CY7113 EZ-PD™ PMG1-S3 MCU prototyping kit release notes

This is the second revision (rev *A) of the CY7113 EZ-PD™ PMG1-S3 MCU prototyping kit. This revision of the kit uses rev04 of the CY7113 board. The board part number (600-60609-01) and revision (REV04) are marked on the top silkscreen of the board.

1.4.1 Change in Rev *A of CY7113

Figure 1 Identifying CY7113 board revision

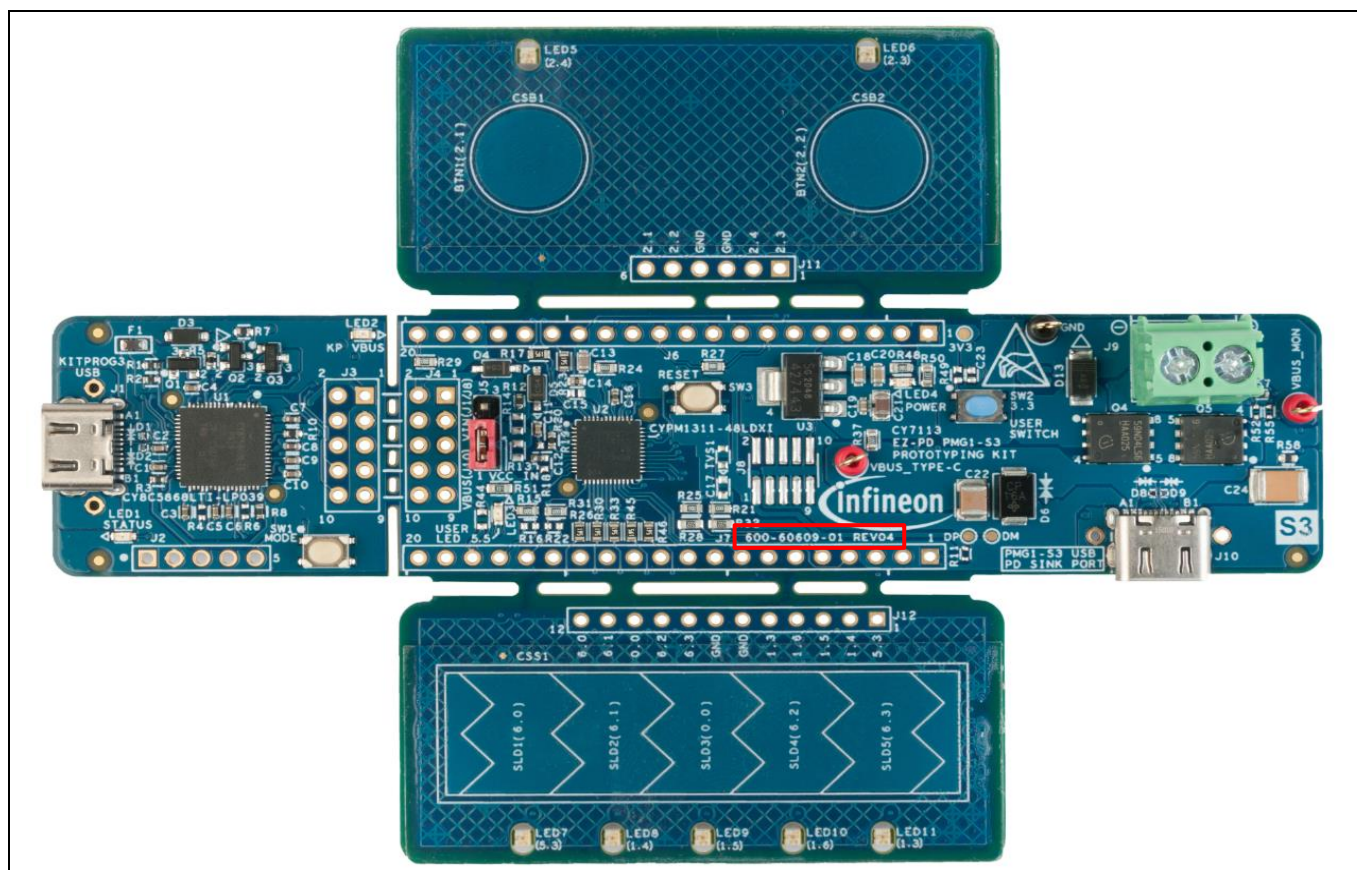
Support for 140 W (28 V, 5 A) is added in Rev *A of the CY7113 kit. This support is enabled using the updated 'USBPD Sink CAPSENSE™' code example that can be downloaded from GitHub. For more details, see the README file associated with the code example. The Rev04 of the CY7113 board readily supports 140 W of power consumption.

Note: The factory firmware loaded on CY7113 Rev04 boards which were manufactured during 2021 support only up to 100 W (20 V, 5 A) of power consumption. The year and work week (WW) of manufacturing can be identified from the label attached to the bottom of the CY7113 board as shown:

Download the latest 'USBPD Sink CAPSENSE™' code example from GitHub through ModusToolbox™ onto the CY7113 Rev04 hardware to enable support for 140 W (28 V, 5 A) of power consumption.
